PROPOSED SUBDIVISION RESIDENTIAL DEVELOPMENT

201 KEARSARGE WAY

RE: Request for Site Plan Approval at 201 Kearsarge Way, Tax Map 218 / Lot 5

The project received a recommendation for Planning Board approval at the February 7, 2020 Technical Advisory Committee Meeting subject to stipulations. The stipulations, as well as our responses to the stipulations, are listed below:

**UTILITY PLAN
AND PROFILE**

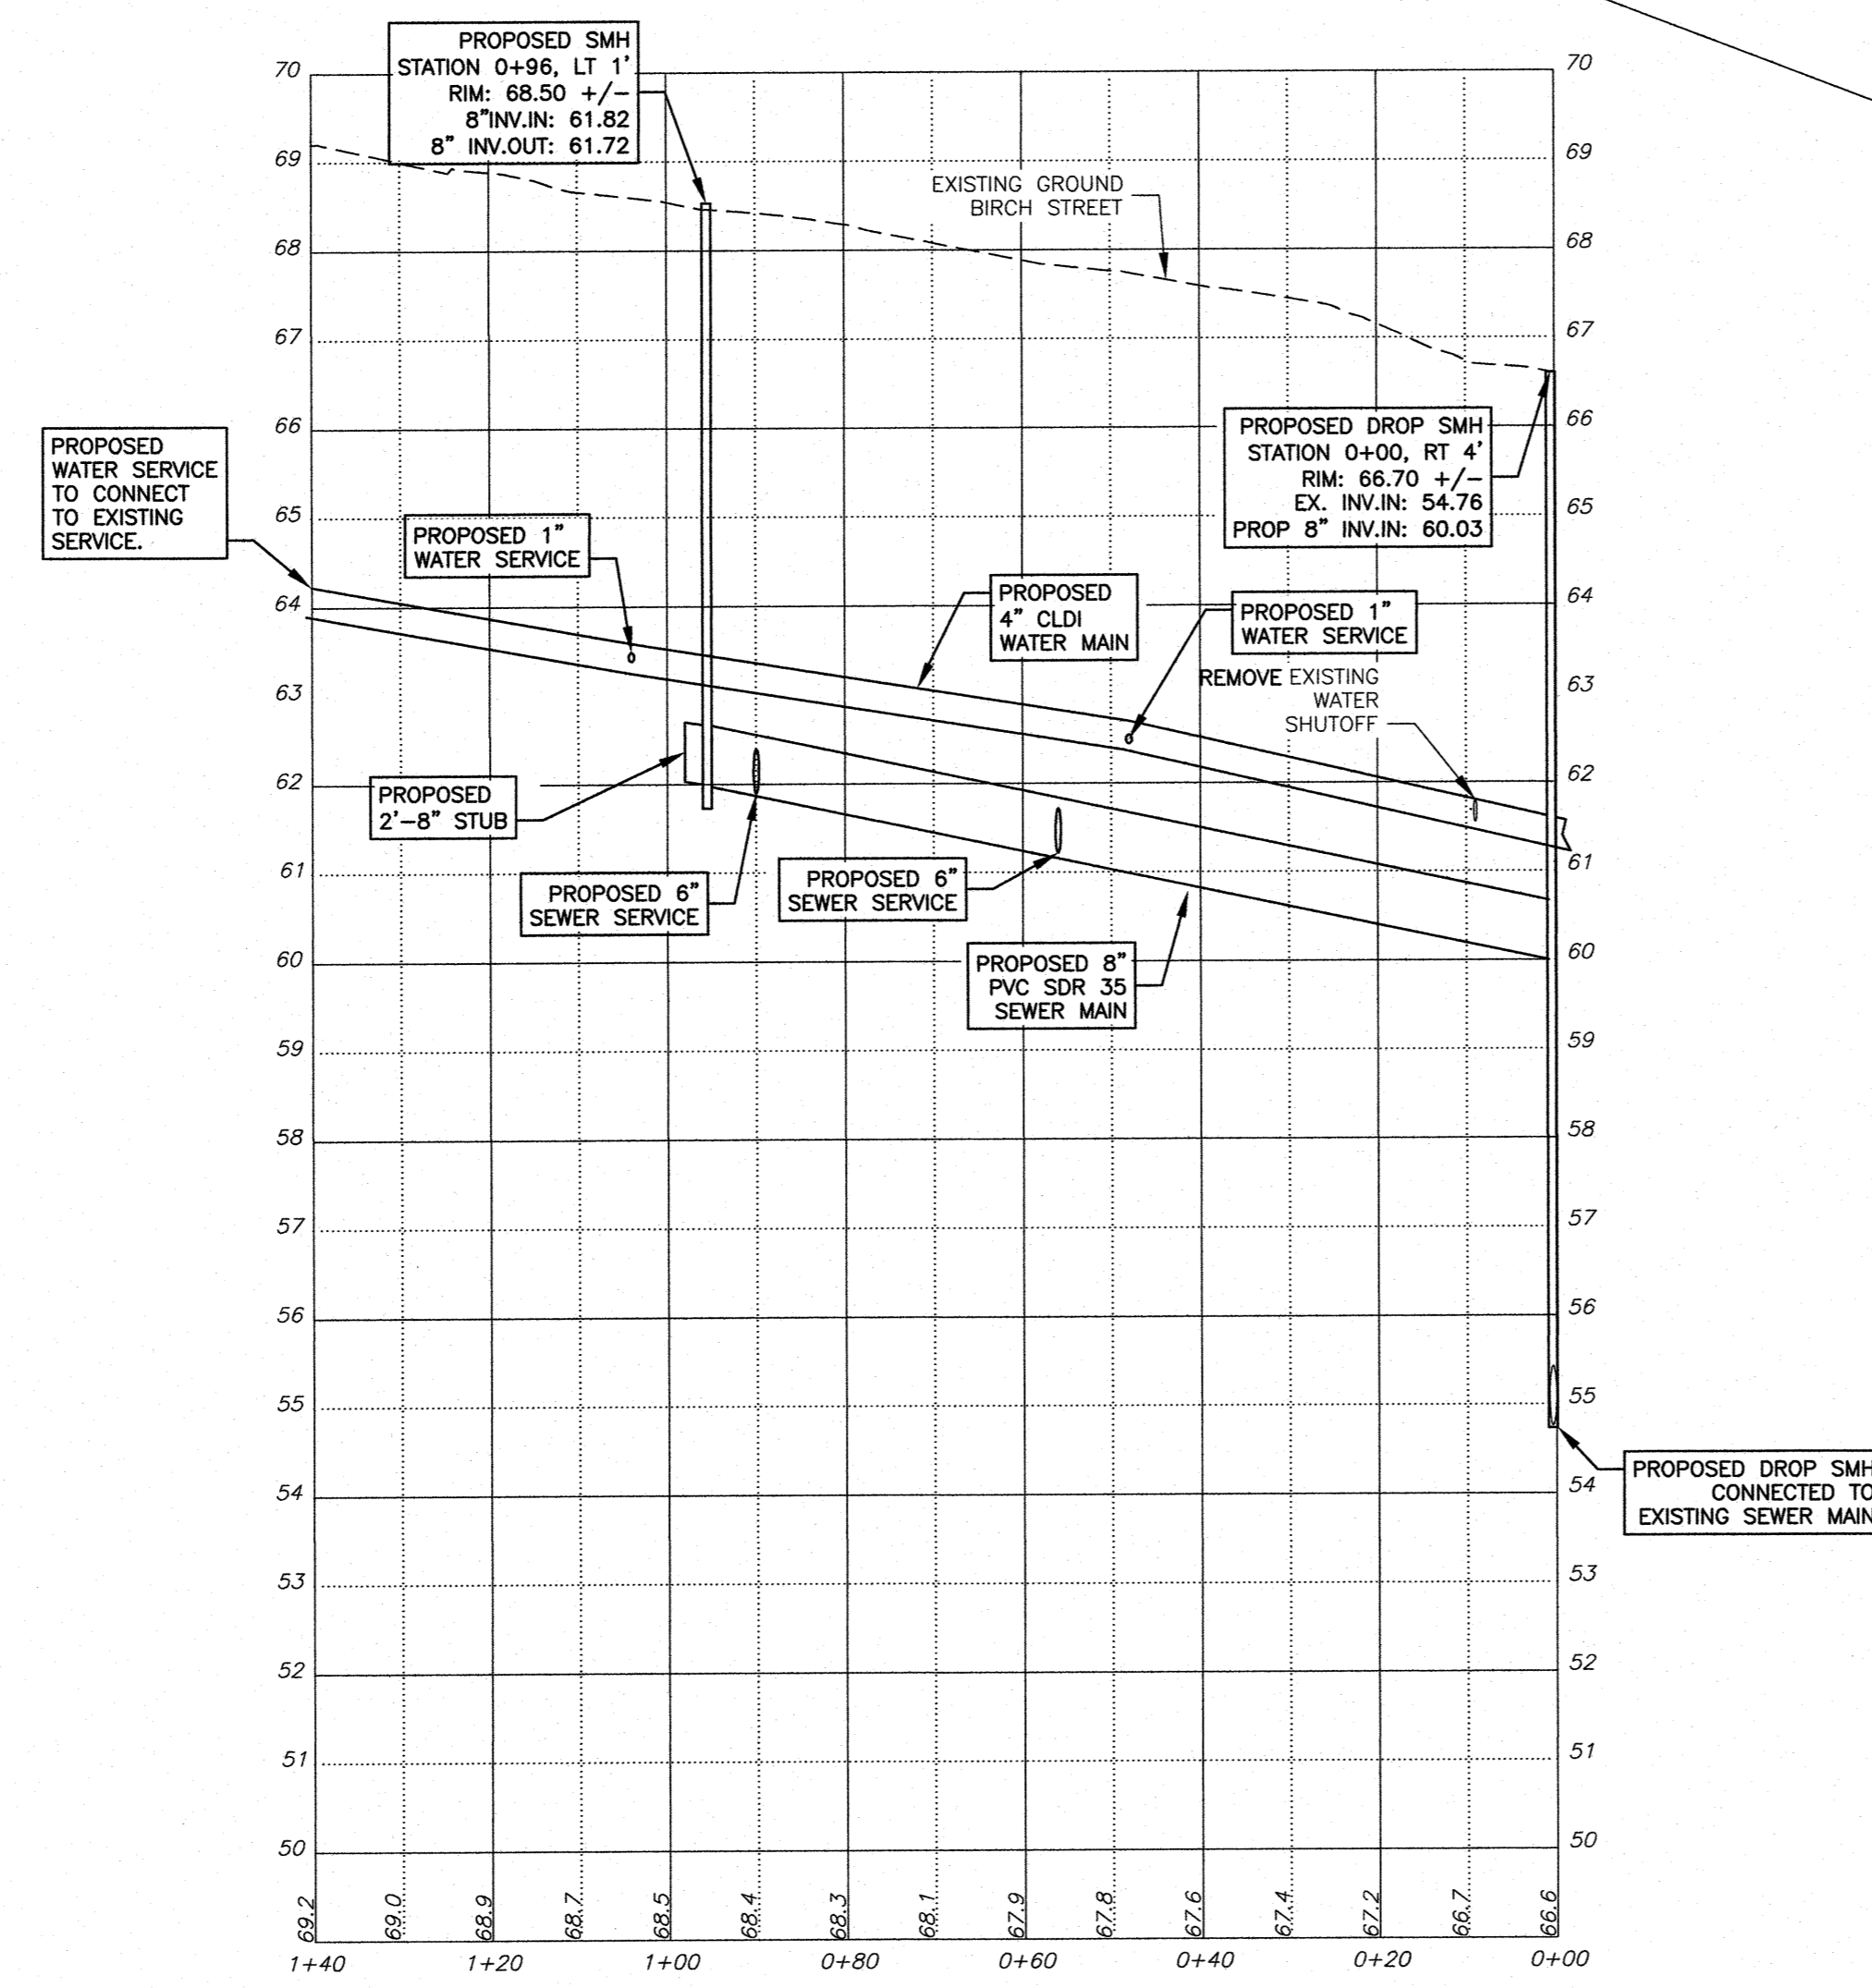
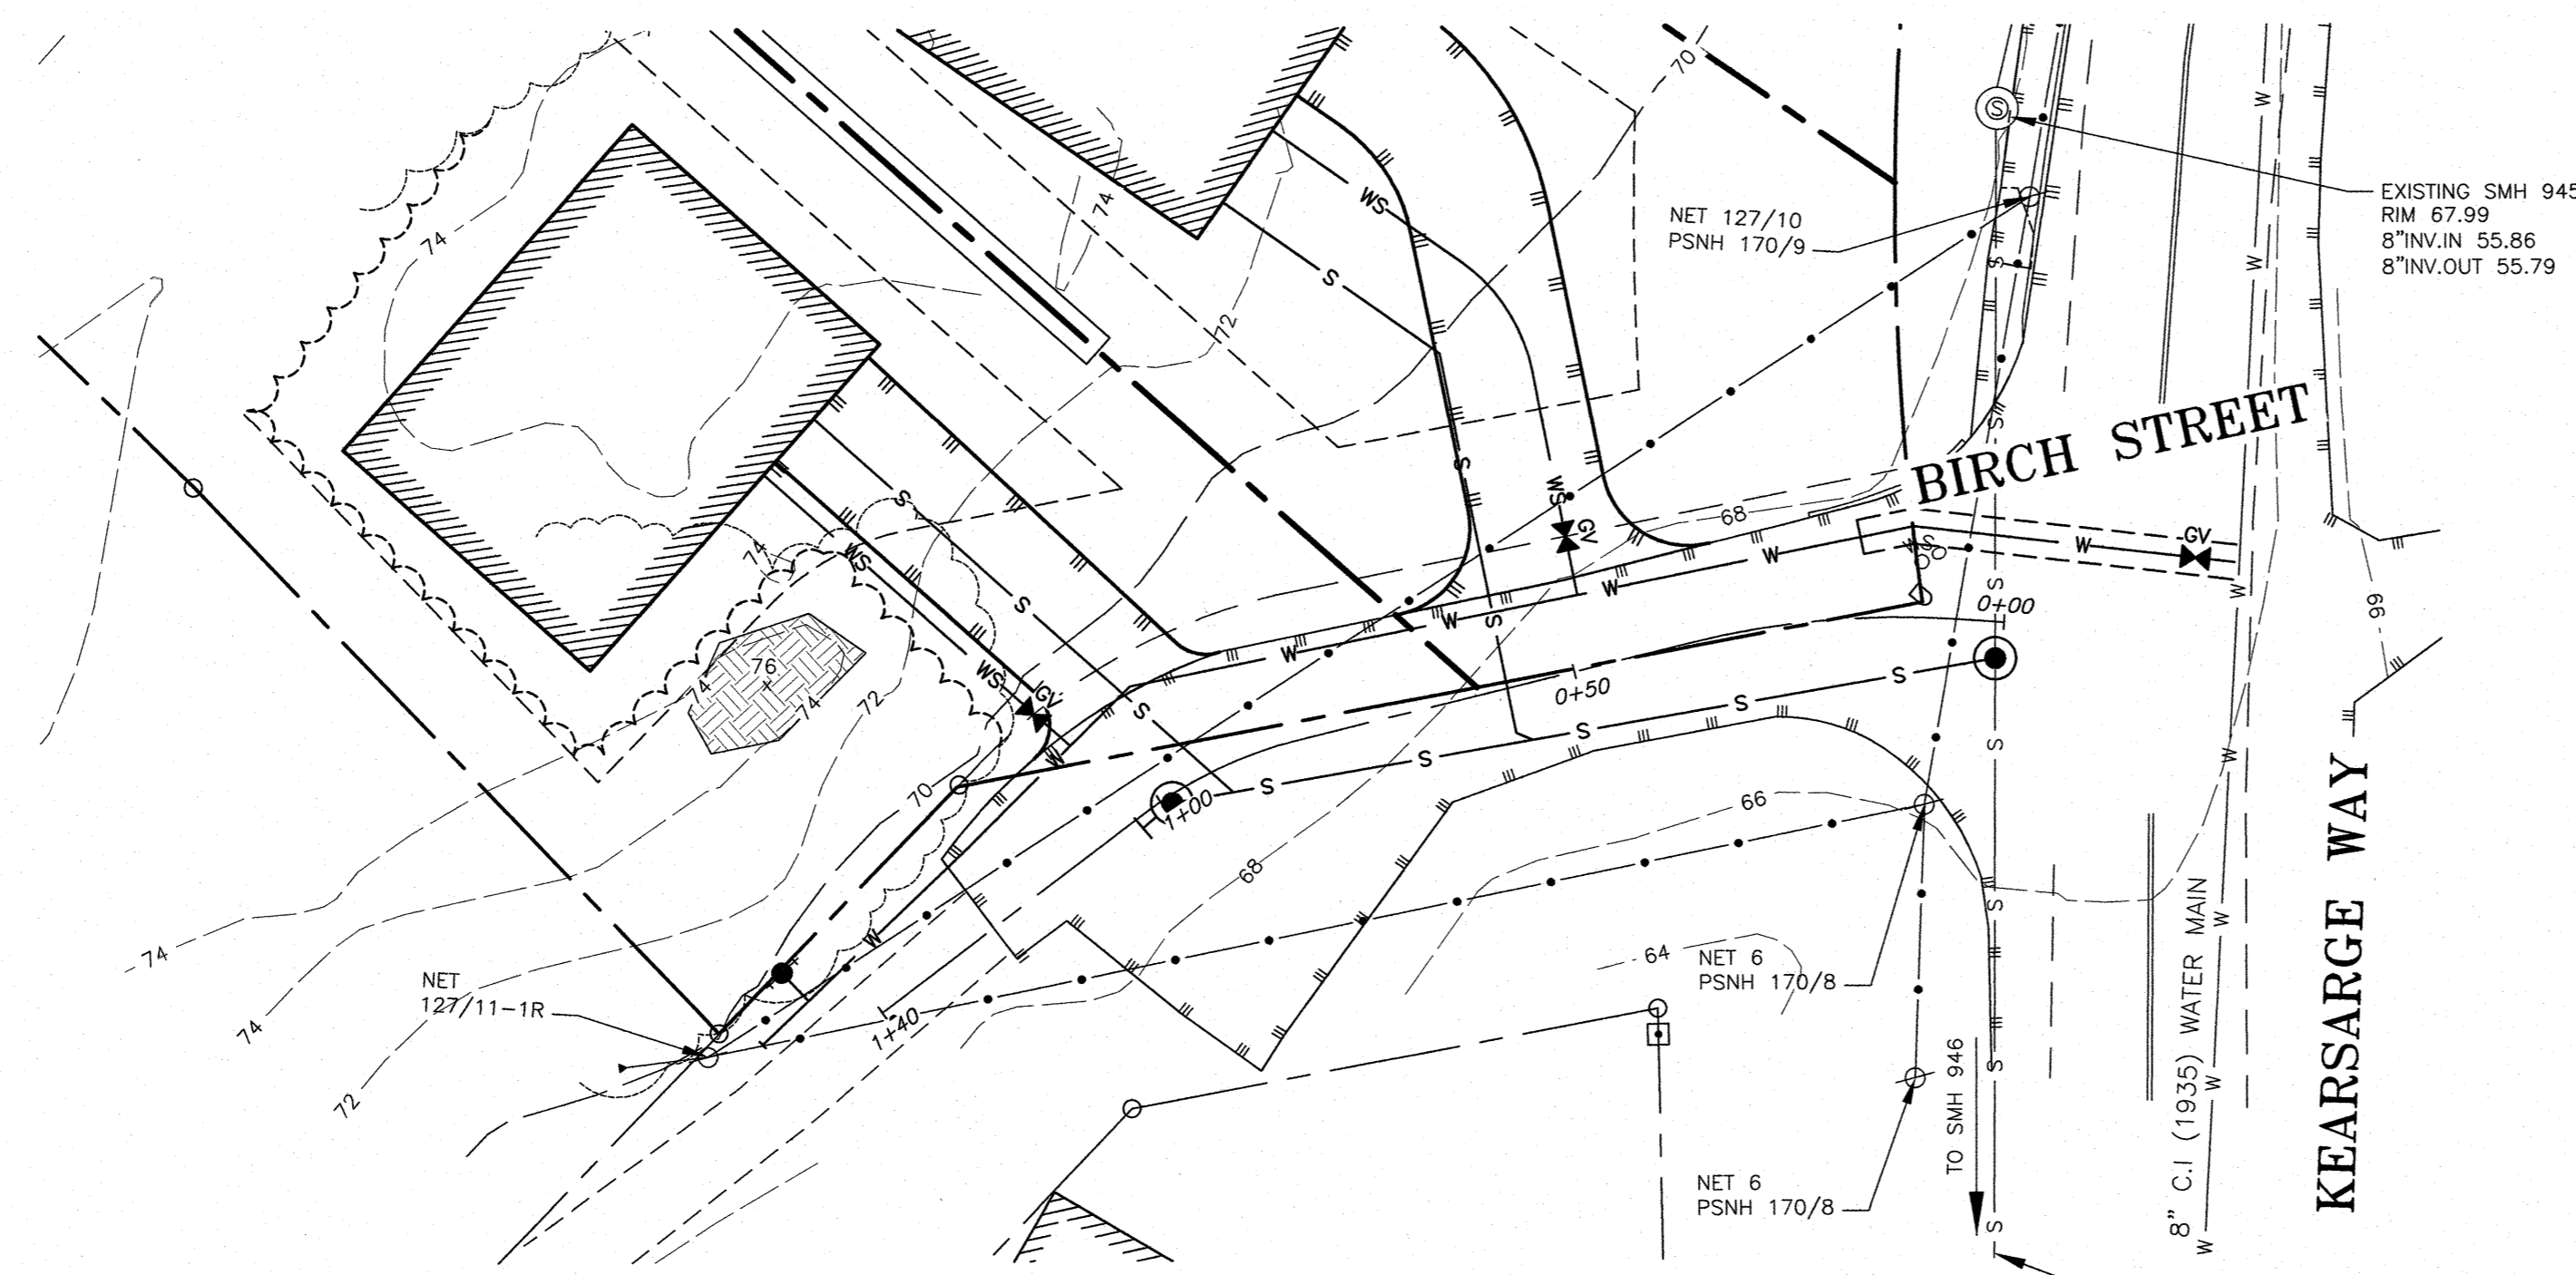
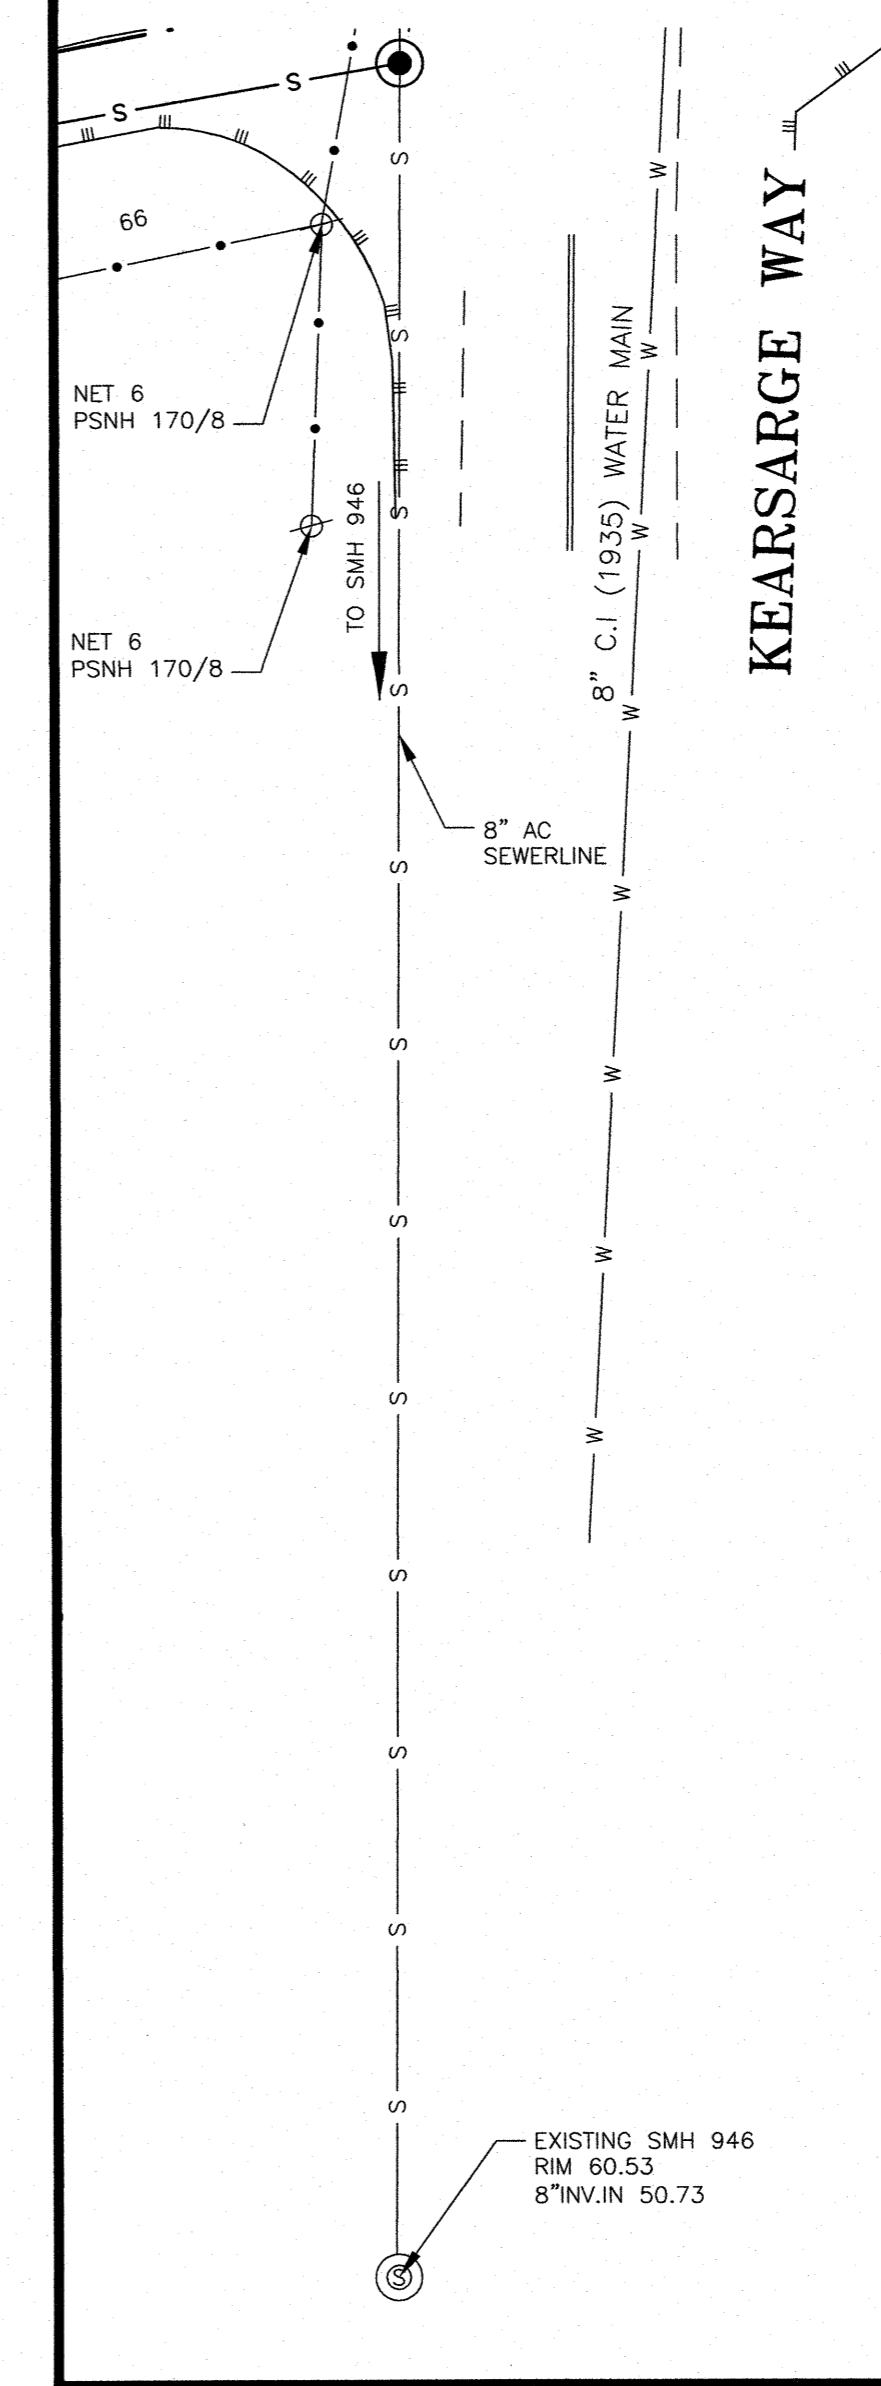
10. 2' stub out of manhole is sufficient. **The Plan and Profile has been revised.**
11. Materials to be approved by Portsmouth Water / Sewer. **Note 4 on Sheet P1 has been added.**

12. Installation of utilities to be witnessed. **Note 5 on Sheet P1 has been added.**
13. Remove detail F / C3, it is incorrect and doesn't meet standards. **The detail has been removed.**

O DROP MANHOLE (INSTALLATION OVER EXISTING MAIN)
C3 NTS

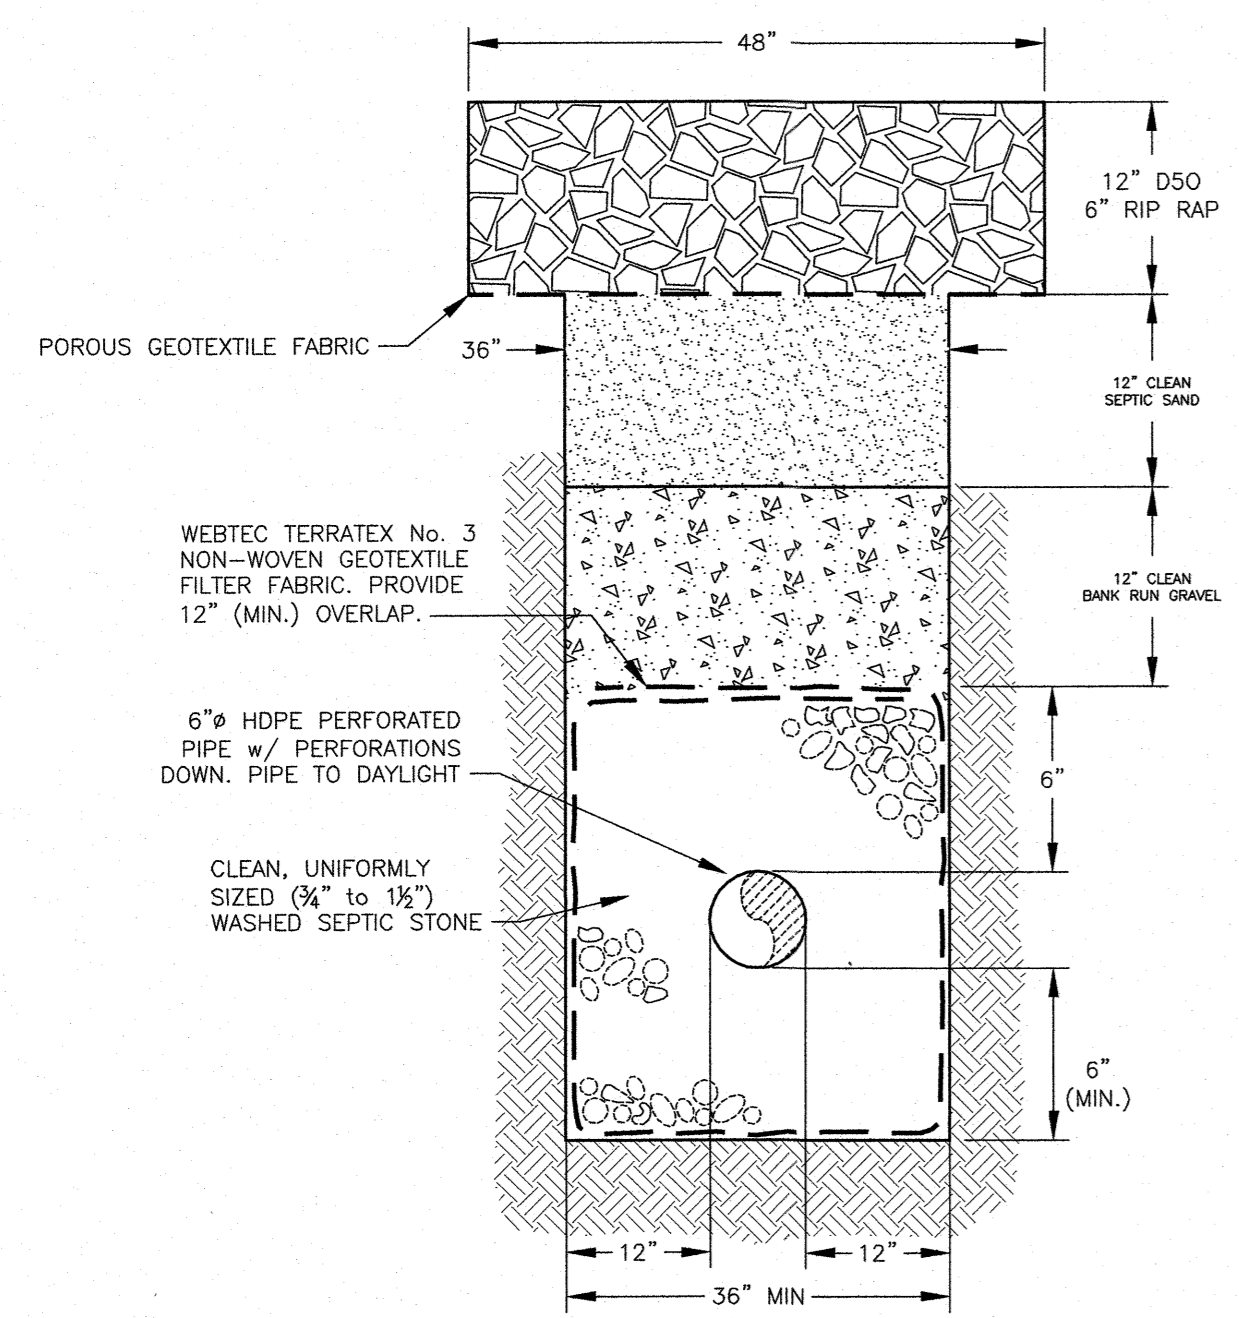
14. Provide City standard detail for drop sewer manholes on plan set. **This has been added as Detail O on Sheet D3.**
15. What is the existing sewer in Kearsarge? It is shown as PVC, AC and Clay on various plans and details. **The existing sewer is listed as AC on the city utility maps; designations have been updated to be consistent.**
